Responses to the reviewers

Title: Identification, Mapping and Eco-hydrological Signal Analysis for Groundwater-dependent Ecosystems (GDEs) in Langxi River Basin, North China (hess-2023-151)

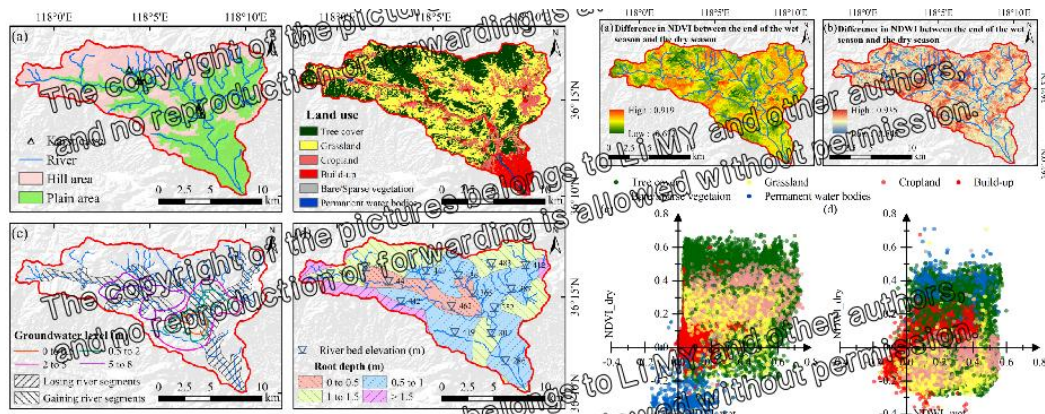
2. The author used data from 2020 to 2021 to divide the scope of GDEs in the Langxi River Basin. This seems to be because the author conducted the experiment during this period. Does this method also work at other times?

Answer: Thank you for your question. First of all, the distribution range of GDEs will change with the amount and range of groundwater recharge. The amount and extent of groundwater recharge will slowly change with the impacts of climate change and human activities. When natural disasters such as earthquakes, coal mining, or human activities cause serious changes in underground aquifers, the distribution range of GDEs may change significantly in a short period of time. During the period when the stratum does not change significantly, long-term groundwater level monitoring data shows that the changes in groundwater levels in the entire LRB and its vicinity are very weak. Therefore, we believe that the distribution range identification method of GDEs proposed in this article is representative. It should be noted that when the groundwater level fluctuates significantly or the stratigraphy changes significantly, we

recommend re-evaluating the relevant indices and parameters in the study area and this system.

We have added relevant discussion of this situation in the Discussion section of the paper.

The quantity and range of groundwater recharge will affect the GDEs' distribution range. The effects of climate change and human activity will gradually alter the volume and scope of groundwater recharge. The distribution range of GDEs can alter dramatically in a short amount of time when major changes are made to subterranean aquifers by natural disasters like earthquakes, coal mining, or human activity. It should be noted that when the groundwater level fluctuates significantly or the stratigraphy changes significantly, we recommend re-evaluating the relevant indices and parameters in the study area and this system. Long-term groundwater level monitoring data indicates that the changes in groundwater levels in the entire LRB and its vicinity are very weak during the period when the stratum does not change significantly. Therefore, the Four diagnostic criteria framework proposed in the study can effectively identify GDEs in areas such as grasslands, deserts, plains, and karsts in arid, semi-arid, and sub-humid areas.

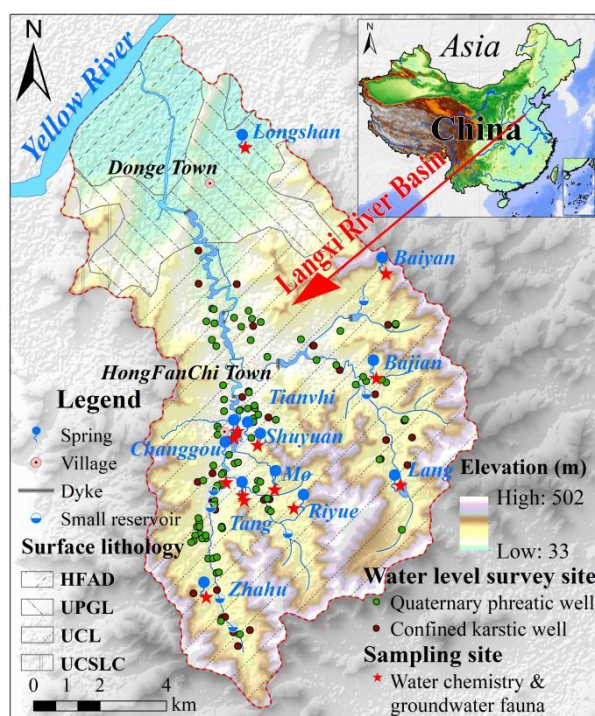
5. The study area map of Line 710 in Figure 1 should be redesigned. It's not pretty now.

Answer: We modified Figure 1, adjusted the layout, and replaced the more difficult-to-understand geological symbols with abbreviations.

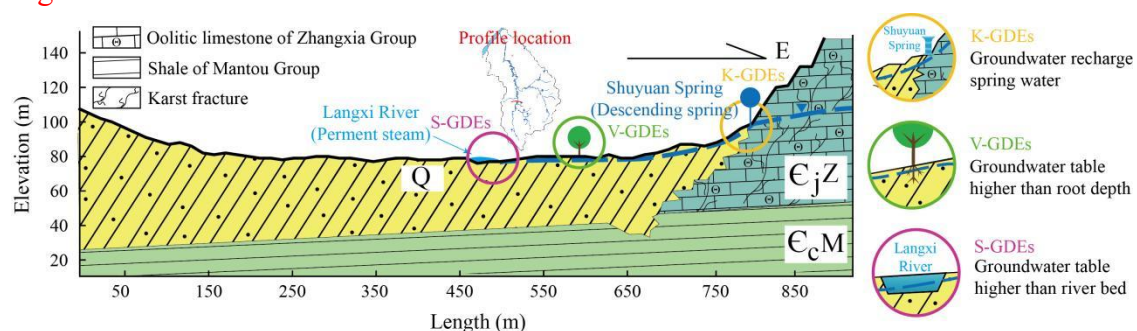
2. The current version lacks substantial supporting information on ecohydrological signals aiding in mapping GDEs. Section 3.4 primarily focuses on the spatial distribution of GDEs within the study area. Sections 3.5 and 3.6 delve into detailed descriptions of hydro-biogeochemical features observed in GDEs. However, there appears to be a weak connection between these descriptions and the verification of various GDEs, as depicted in Figure 2. Strengthening this connection is essential for a more cohesive presentation of the study's findings regarding the role of ecohydrological signals in GDE mapping.

(1) The section shown in Figure 2 has important connections with Section 3.3.1. Section 3.3.1 describes the lateral recharge relationship of groundwater to the Langxi River. In response to this, this study conducted a geological survey on the Shuyuan Spring and Langxi River sections, and explored the relationship between the groundwater level and Shuyuan Spring, as well as relevant information about the stratigraphy of the sections. In the text, we reformulate the connection between Figure 2 and Section 3.3.1. And in order to increase relevance, we modified Figure 2 to more clearly represent the three types of GDEs present in the modified typical section.

The Shuyuan Spring and Langxi River profile (hereinafter referred to as the Shuyuan Spring profile, Figure 2) shows the location and elevation relationship between groundwater and the Langxi River profile. The eastern Cambrian Zhushadong-Zhangxia Formation limestone is rich in groundwater buried deeper than the river. Shuyuan Spring, one of the descending springs in the basin, gushes out at the intersection of the Quaternary sedimentary layer and the Cambrian Zhushadong-Zhangxia Formation limestone. At the same time, groundwater also recharges to the Langxi River along the stratigraphic fissures.

Figure S1. Different slopes distinguish the plain and hilly results of LRB.

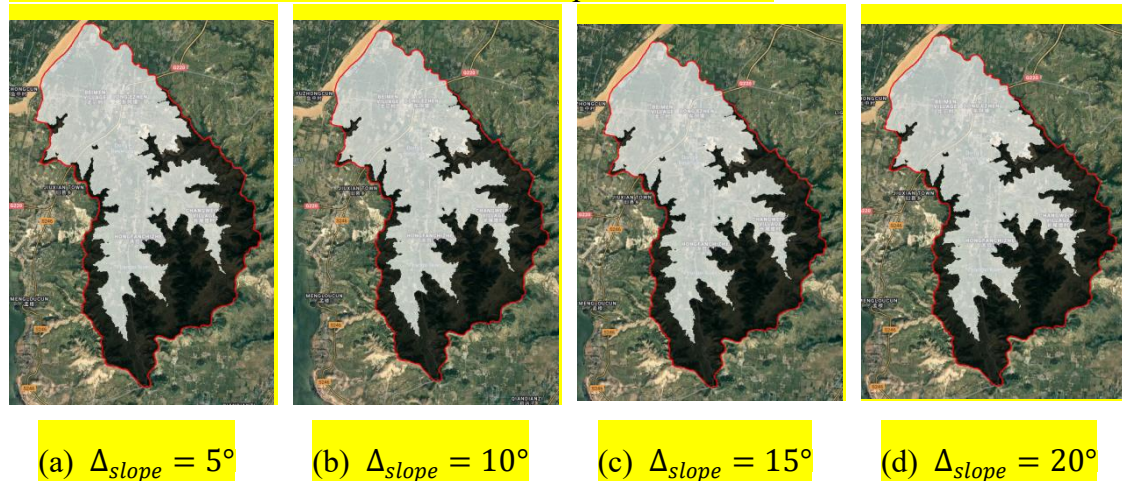
Page 6, Line 183: Please clarify the scale behind select a 10-degree angle.

Answer: In the original article, we briefly stated "The determination of this parameter can be manually adjusted based on one-third of the average slope of the basin until the plains and mountains are clearly distinguished." In response to experts' suggestions, we first put the method of parameter determination and the results of selecting different parameters into a supplementary file. This will allow readers to better understand my approach.

where, $grid_{plain}$ represents the grid divided into plains; Δ_{slope} is the threshold of the maximum plain slope, in this paper we take $\Delta_{slope} = 10^\circ$. The determination of this parameter can be manually adjusted based on one-third of the average slope of the basin until the plains and mountains are clearly distinguished (See Supplementary material I).

Below, Figure S1 shows our results of plain and hill classification using 4 different slopes. It can be seen that except for minor differences in details, overall slope does not have a great impact on plains and hills in LRB. This is due to the fact that the mean elevation limits the role of slope in this basin.
